## Application for Licence Amendment

<b>Licence Number</b>	L4247/1991/13
<b>Licence Holder</b>	Talison Lithium Australia
<b>ACN</b>	139 401 308
<b>File Number</b>	2012/0071641
<b>Premises</b>	Talison Lithium Mine  Maranup Ford Road, GREENBUSHES WA 6254.  Legal description - Mining Tenements M01/3, M01/6, M01/7, M01/8, M01/9, M1/16, G01/1 and G01/02 (As defined by the premises maps attached to the Amended Licence)
<b>Date of Report</b>	12 July 2023
<b>Decision</b>	Revised licence granted

**Figure 4 Correct methodology to calculate 15-minute rolling averages for TSP measured by the Osiris monitors**

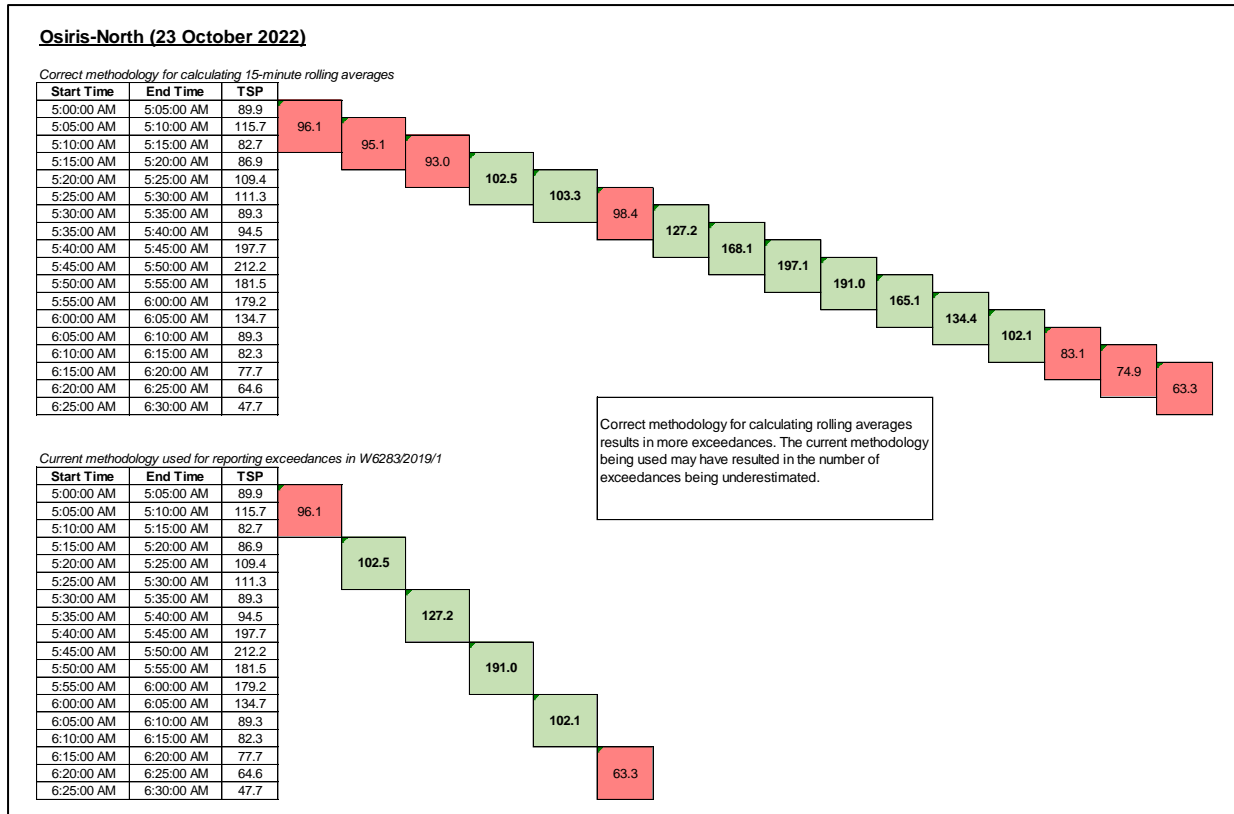
The department has also reviewed the methodology the licence holder was using to calculate 15-minute rolling averages for TSP concentrations as required by condition 9 of works approval W6283/2019/1. The TSP trigger value of 100 µg/m<sup>3</sup> set in condition 9 is based on the average TSP concentration in three consecutive 5-minute intervals. It was identified that the methodology being used by the licence holder when reporting 15-minute rolling average data may have resulted in the underestimation of TSP exceedances. The correct method is detailed in Figure 4.
